Project Title: Refurbish Elevators and Replace Controls

Solicitation Questions and Answers
for
Refurbish Elevators and Replace Controls
Project: 437-22-101, RFP: 36C26324R0021
12/15/2024

Solicitation Questions and Answers (updated 3-26-2024) for
 Refurbish Elevators and Replace Controls
 Project: 437-22-101, RFP: 36C26324R0021

8 ELEVATION - ELEVATOR 12 - TYPICAL
1/2" = 1'-0"

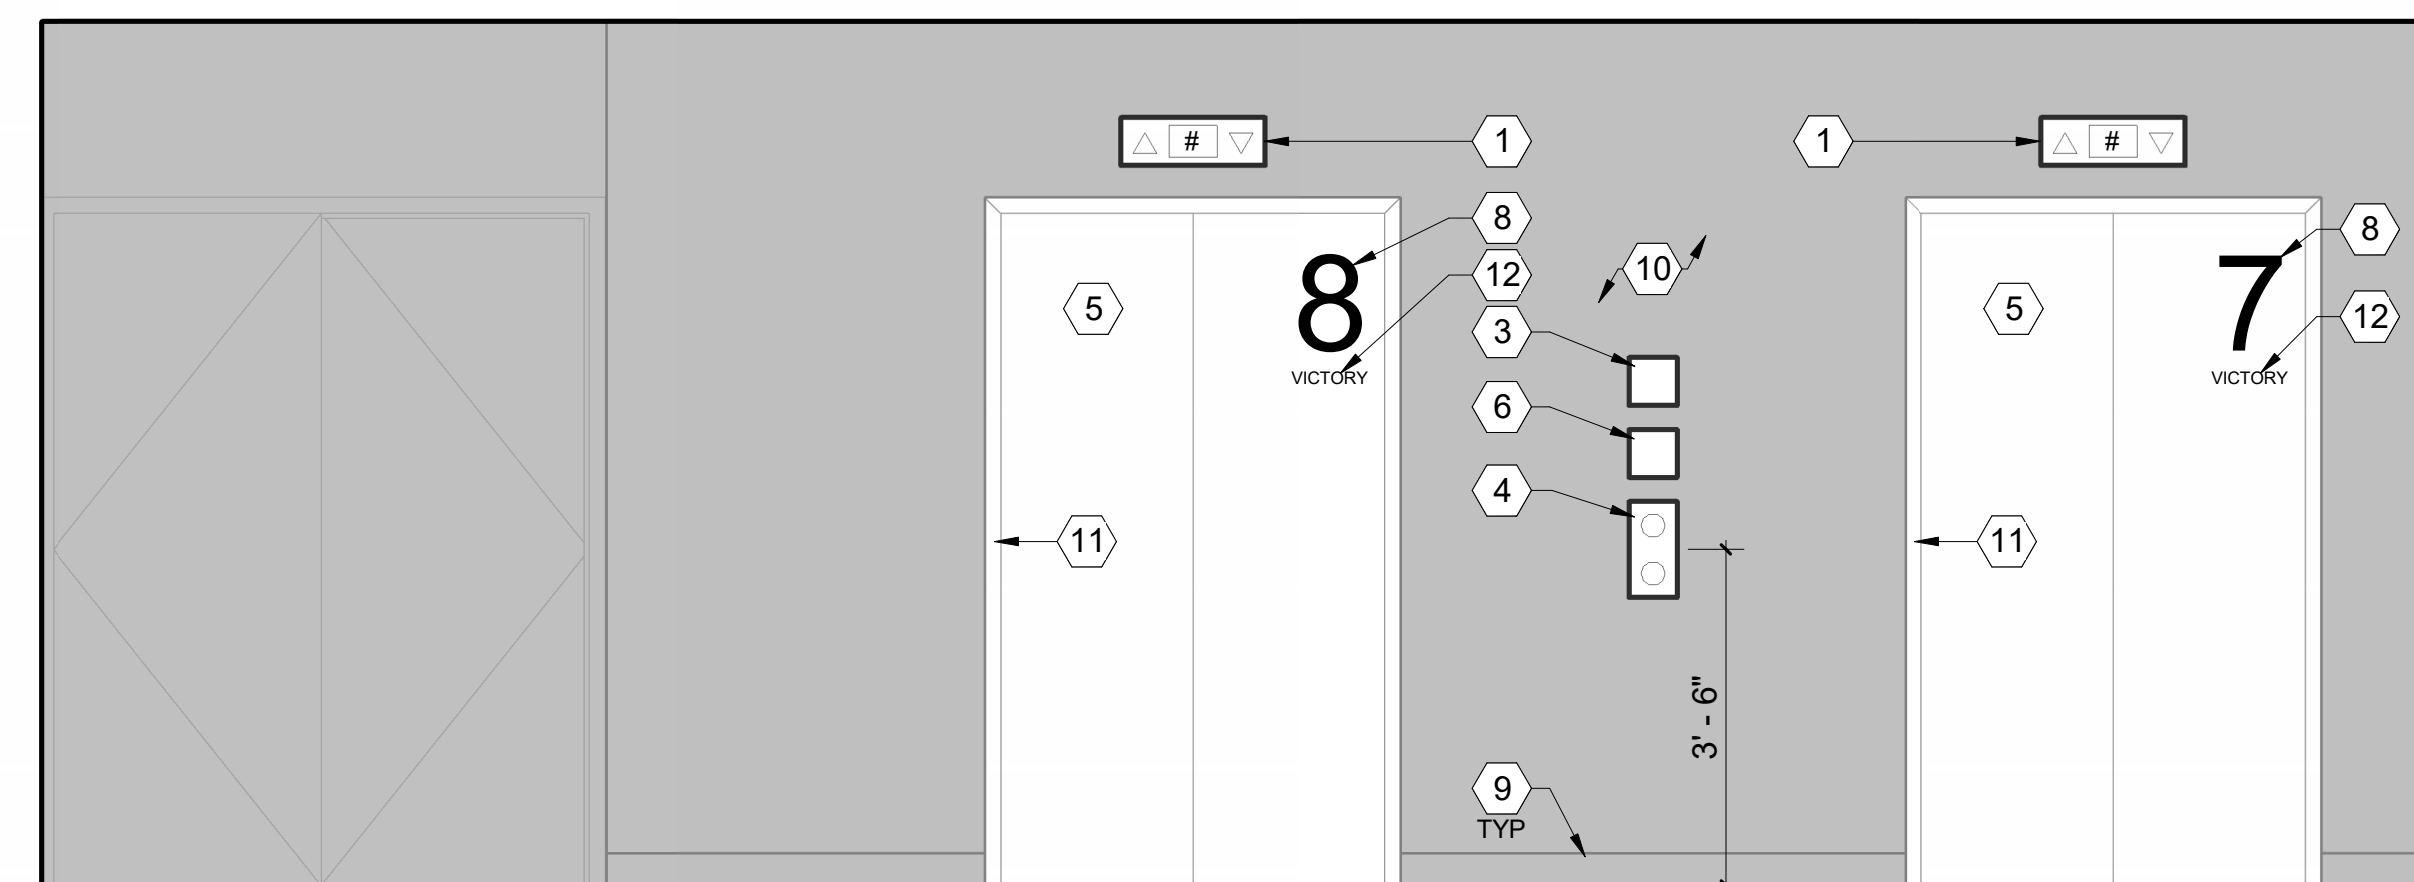
93.	Drawing A5.30 Keynote 10	When wall finishes need to be replaced/repared, will it be acceptable to paint instead of wallpaper, or does VA have leftover stock on wallpaper? If new wallpaper needed, please provide spec of existing.	VA Will provide matching wallcovering stock if they have it available. If matching wall covering is not available, then matching painting will be required.

Drawing Sheet A5.30 INTERIOR ELEVATIONS - LOBBIES – See revised drawing sheet for the adjustment of keynotes # 11.
